## FALSE WARNINGS THAT THE FRONT PASSENGER SEAT IS OCCUPIED WITHOUT THE SEAT BELT BUCKLED

This Service Information bulletin supersedes SI B72 04 17 dated **December 2017**

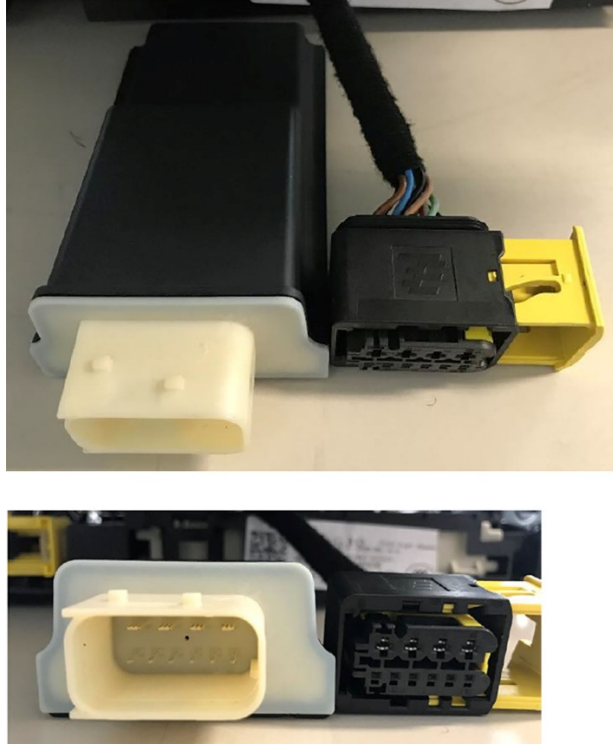
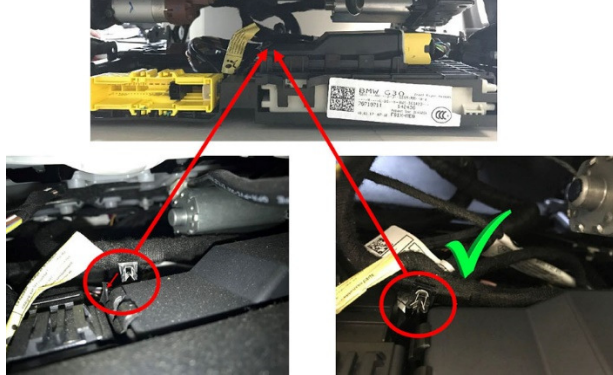
<ol style="list-style-type: none"><li>1. Move the front seat to its highest position.</li><li>2. Detach the lower front seat trim.</li><li>3. Disconnect the Evaluation Electronics (CIS) plug connection.</li></ol>
	<ol style="list-style-type: none"><li>4. Check the plug for conditions resulting in possible poor electrical connection – corrosion, bent pins, etc. – removing control unit if needed, as shown.</li><li>5. Repair any connection problems.</li><li>6. Securely re-install control unit, if removed.</li><li>7. Reconnect plug into CIS.</li></ol>
	<ol style="list-style-type: none"><li>8. Secure the loose clip attached to cables, as shown.</li></ol>

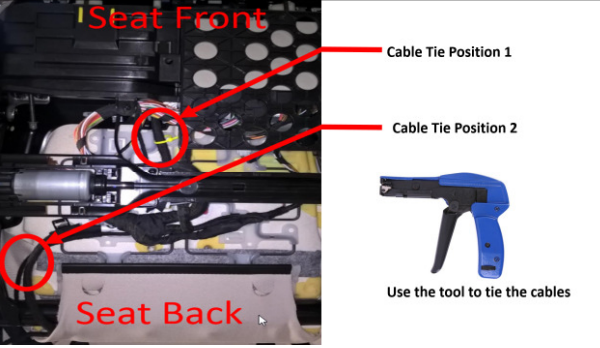
<p>First cable tie position as shown in abov photo</p>	<p>Secound cable tie position as shown in abov photo</p>
	<p>9. Using 2 cables tie to secure wiring harness, as shown.</p>
